ADDENDUM NO. 4

RE: **GS# 211-071**
Hayden Hall Renovations
Perkinston Campus
Mississippi Gulf Coast Community College
Perkinston, Mississippi
A/E Project No. 22-050

FROM: Eley Guild Hardy Architects
1091 Tommy Munro Drive
Biloxi, MS 39532
(228) 594-2323

ADDENDUM 3 - PARTIAL ENLARGED LOBBY AND APARTMENT PLUMBING PLAN

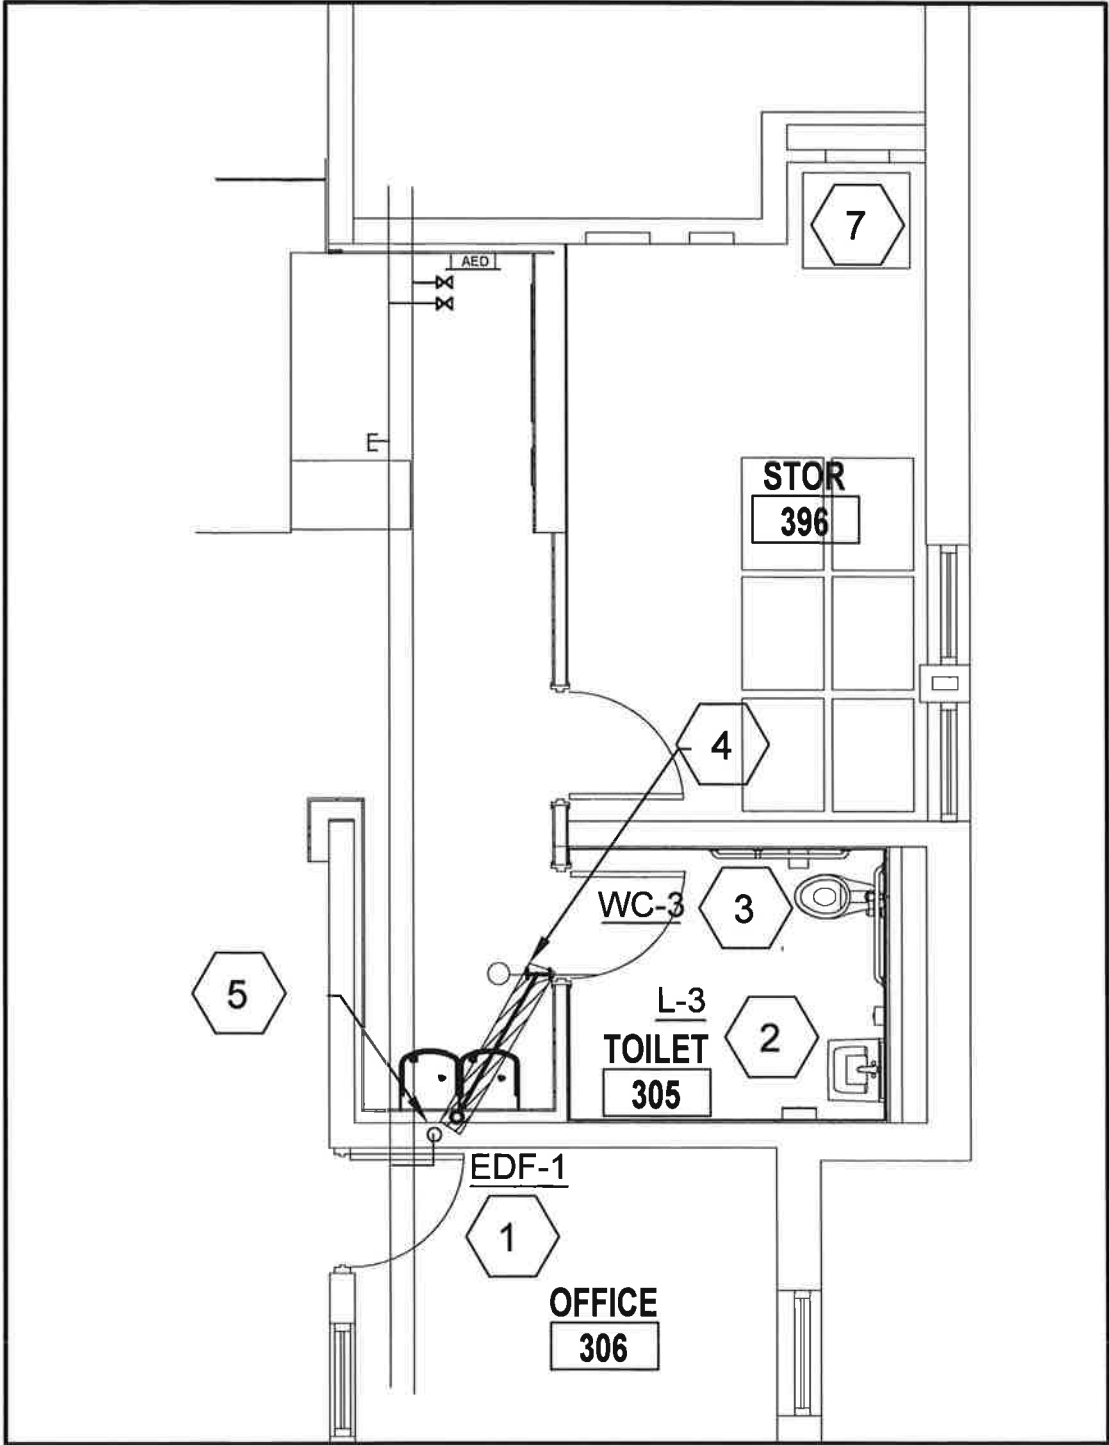
6. **Sheet P202 Enlarged Lobby Apt Plumbing Plan:** EDF-1 is shown in doorway to restroom hallway with true EDF-1 location at end of hallway. Locate as shown in hallway access to toilet. See attached partial plan “Addendum #4 Partial Enlarged Lobby and Apartment Plumbing Plan”. Be advised the demolition plan for trenching will follow this plan.
